PG&E Comments on
California Coastal Power Plants
Cost and Engineering Analysis of Cooling System Retrofits
Draft Prepared by Tetra Tech

2. COMMENTS ON CHAPTER 7C — DIABLO CANYON POWER PLANT

Figure C-6. Cooling Tower Locations

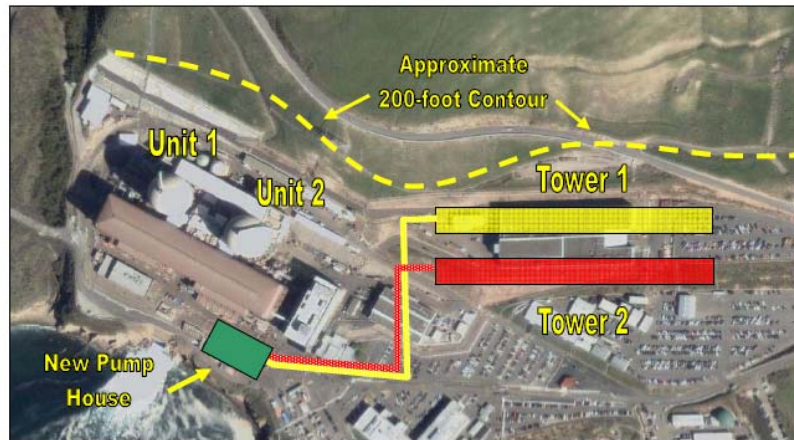
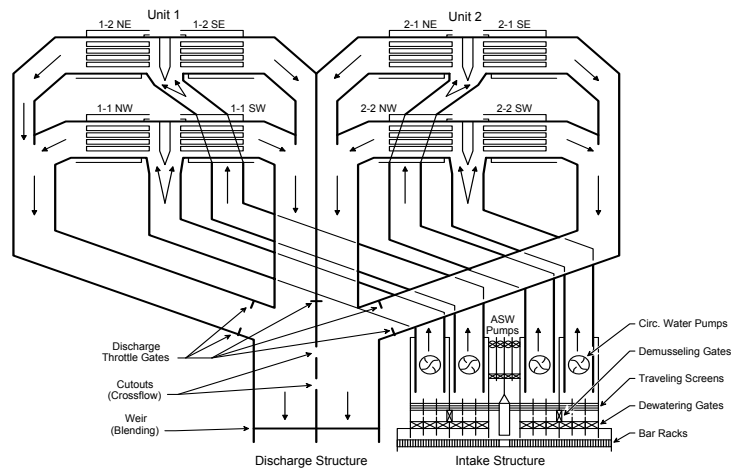
The location of the new Pump House as shown in Figure C-6 blocks access to the Turbine Building crane bay where all large pieces of machinery (turbine rotors, generators, pumps, etc) enter and exit the building. Its proposed location is technically unacceptable.

Tetra Tech provides a very simplistic non-detailed description of the implementation of the new pump house and the interconnection of the new piping to the existing circulating water conduits. Figure C-6 shows Tetra Tech's simplified sketch of the pipe routing between the new pump house and the towers, but fails to address how and where the interconnection to existing supply and return conduits would be accomplished and the magnitude of the safety and non-safety related systems that would be severely impacted and would physically interfere with the design and the proposed construction.

FIGURE 6 - Plan View of Tie-in Underground Construction Conditions in Front of Turbine Building

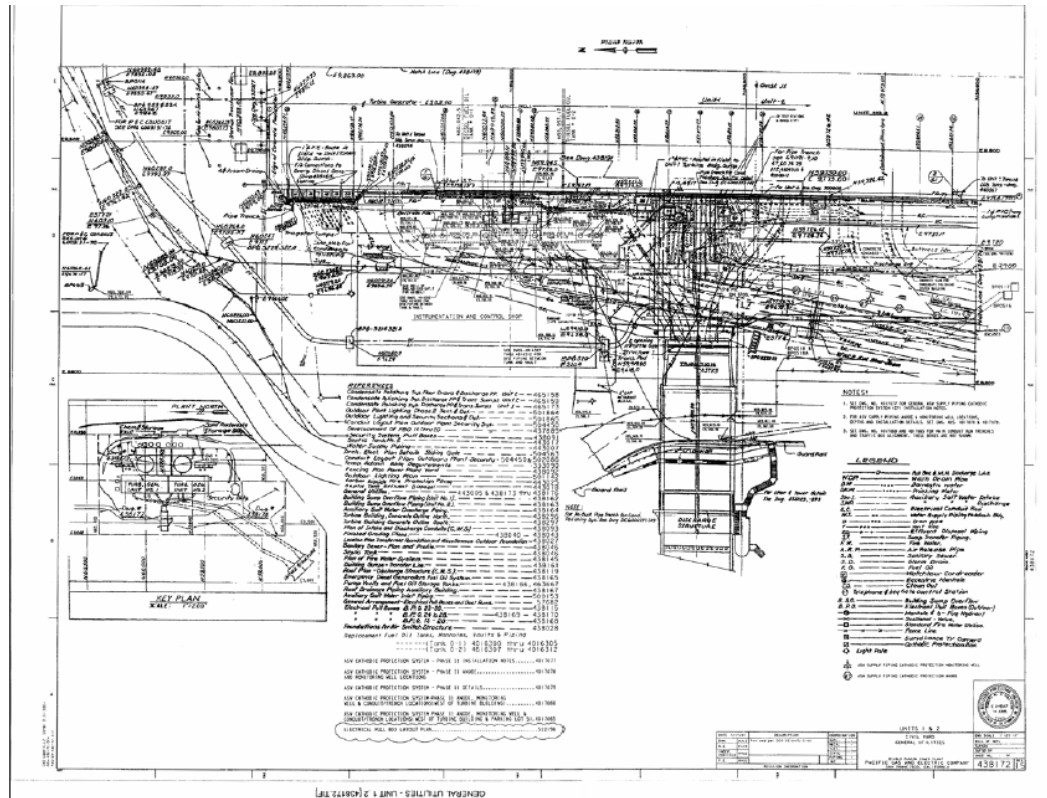
The following schematic shows the existing circulating water conduits to the condenser. Connections would have to be made to all the supply and return conduits including those coming from the north end of the Unit1 condenser. A review of detailed site drawings indicates that the excavations and routing required for these large-diameter connections would be an extremely difficult, if not impossible, engineering task .

The limited area for this inter-tie in front of the turbine building is extremely congested with both safety-related and non-safety-related systems, piping and conduits.

The Tetra Tech study does not sufficiently address if it is even possible to route the large diameter piping in this area, nor the disruption of the numerous systems that would have to be relocated to accomplish this construction. The safety-related ASW system bisects this area and is required to remain in operation even with both units shut down. The difficulty, time and cost associated with these excavations, tie-ins and system interferences is immense. The development of the details of this aspect of the retrofit would lead to numerous obstacles which were not sufficiently addressed by Tetra Tech.
